Project	<b>IEEE 802.16 Broadband Wireless Access Working Group</b> < <a href="http://ieee802.org/16">http://ieee802.org/16</a> >	
Title	<b>Clarification on the allocation for beamformed pilots</b>	
Date Submitted	<b>2005-01-11</b>	
Source(s)	Qinghua Li, Xintian Eddie Lin, Minnie Ho, Randall Schwartz, Jose Puthenkulam <b>Intel Corporation</b>	<a href="mailto:qinghua.li@intel.com">qinghua.li@intel.com</a> Voice: +1-408-765-9698
Re:		
Abstract	Enable closed-loop MIMO channel estimation using partially beamformed midamble	
Purpose	Adoption of proposed changes into P802.16e <del>Crossed out indicates deleted text,</del> <u>underlined blue indicates new text change to the Standard</u>	
Notice	This document has been prepared to assist IEEE 802.16. It is offered as a basis for discussion and is not binding on the contributing individual(s) or organization(s). The material in this document is subject to change in form and content after further study. The contributor(s) reserve(s) the right to add, amend or withdraw material contained herein.

# Clarification for the Allocation of Beamformed Pilots

Figure 1 Illustration of a non-beamformed midamble from 4 BS antennas and beamformed pilots for 2 spatial channels.

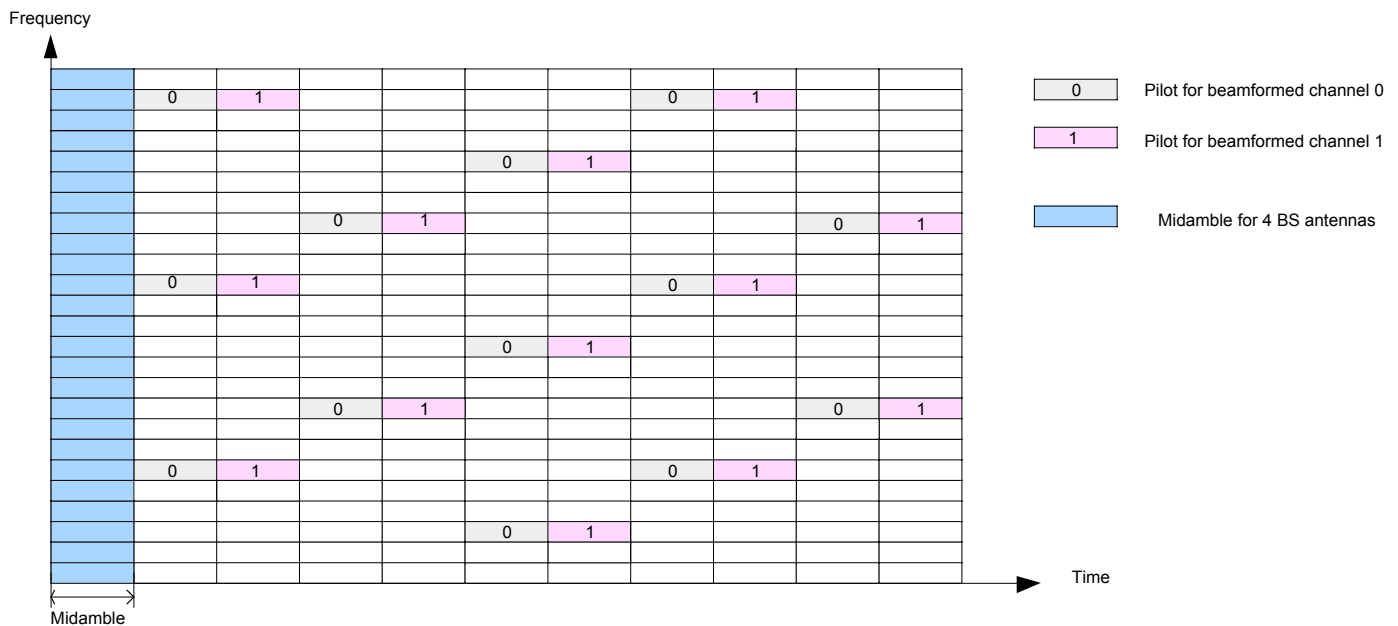
Dedicated pilot for MIMO beamforming mode is accepted by the D5a standard in November meeting. The dedicated pilots are beamformed to send enhanced training signals for the beamformed spatial channels to one or multiple subscriber stations, and other unintended stations usually can not receive them correctly. According to section 8.4.8.3.1 in D5a, a pilot has to be assigned for each BS antenna. However, this is not necessary and efficient for the dedicated pilot case defined in section 8.4.5.3.4 because only the beamformed spatial channel carrying data needs a pilot. For example, a 4x2 link with 4 BS transmit antennas and 2 SS receive antennas can send at most 2 spatial streams. The BS doesn't need to send pilots for its 4 antennas while it employs dedicated pilots for the beamformed spatial channels. Therefore, the BS only need to send pilots for at most 2 (rather than 4) spatial channels using the pilot allocation defined in section 8.4.8.3.1. This not only reduces pilot overhead but also improves channel estimation at the SS. An example is shown in Figure 1.

When the data allocations are transmitted over m beamformed spatial channels and the Dedicated Pilots bit is set to 1, the dedicated pilots are sent only over the m beamformed spatial channels that carry data.
